For owners who've had unresolved air-flow related errors or problems with their Rika / Austroflam Premium or Visio stoves (ER3, ER4, Blinking Display, ER0/CL, ERR/CL, unexplained shutdown due to air flow problems) there is the potential for an air leak on the underside of the hopper.

This is the view from the left side of the stove. The image shows a clear gap between the auger shaft housing and underside of the hopper sheet metal. (both the right and left sides of the stove should be checked.

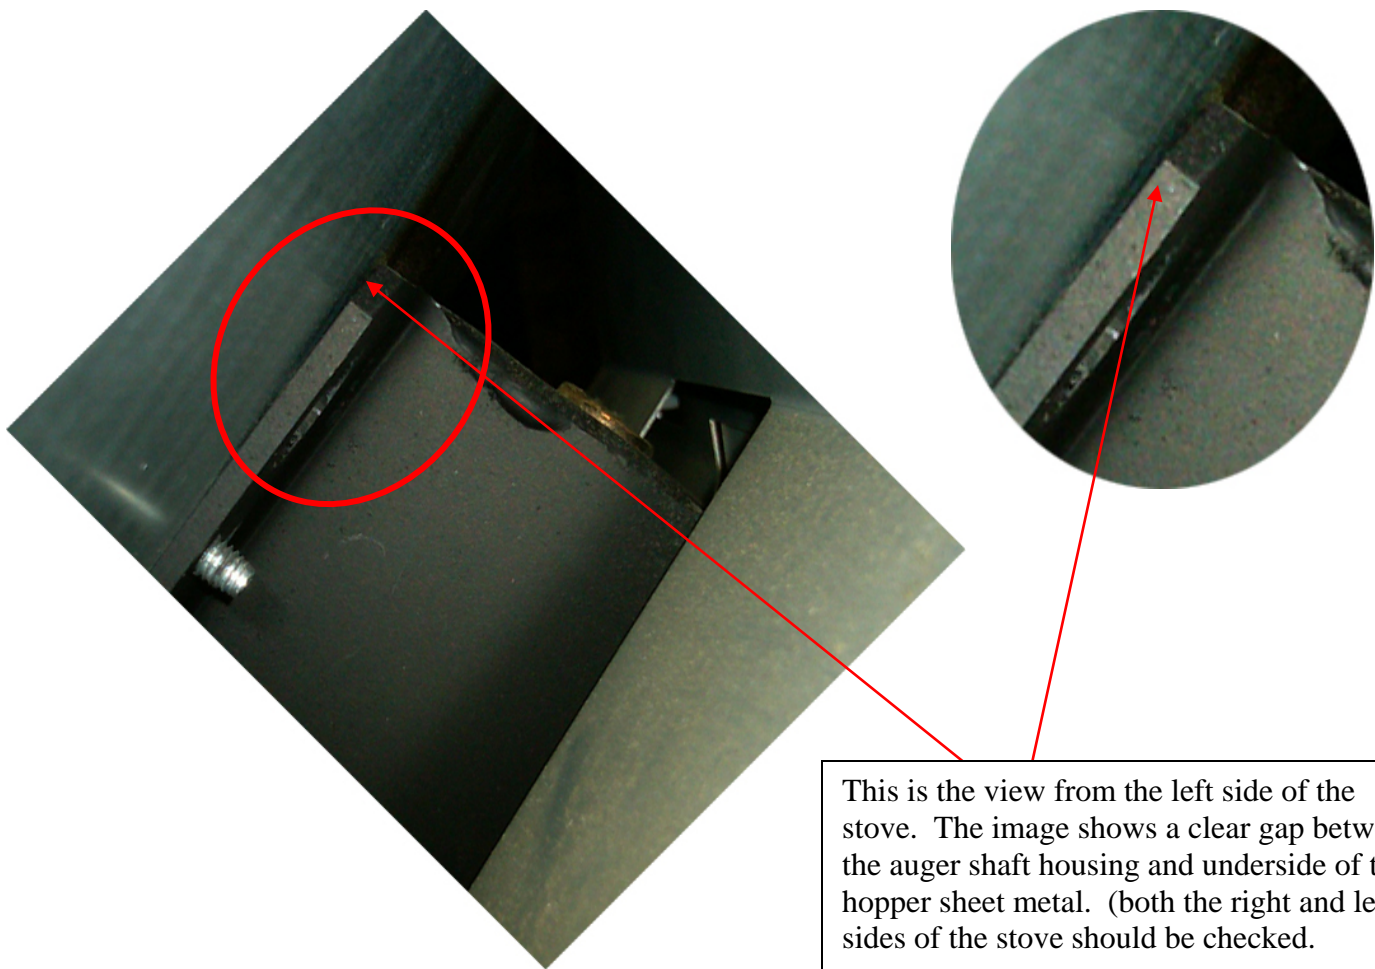
The specific area is the black cast iron box/housing containing the auger shaft where it comes in contact with the sheet metal surface on the underside of the hopper. The most likely place for the leak, if it exists, is at the top of the housing closest to the firewall. Although it's difficult to see in the images, there is a gap where these two surfaces don't meet flush, and there is no gasket between the two surfaces to ensure a sealed fit.

If this condition exists, there is an inward draw pulling the air through the gap. This allows too much air to be introduced past the burn pot. There is a high probability that this would cause air flow problems. Any air leaking in this area is not registered by the air flow sensor, so the sensor would have a difficulty regulating proper air flow as it attempts to compensate for the leak.

If this condition is found, the solution is to use hi-temp silicone to seal the two surfaces together and stop the leak. For cosmetic purposes, we recommend using black silicone, but red silicone is acceptable. For safety purposes, the silicone must be suitable for use with a hearth appliance, with a minimum 600° temperature rating.

If a gap is found, the effected areas should be sealed.
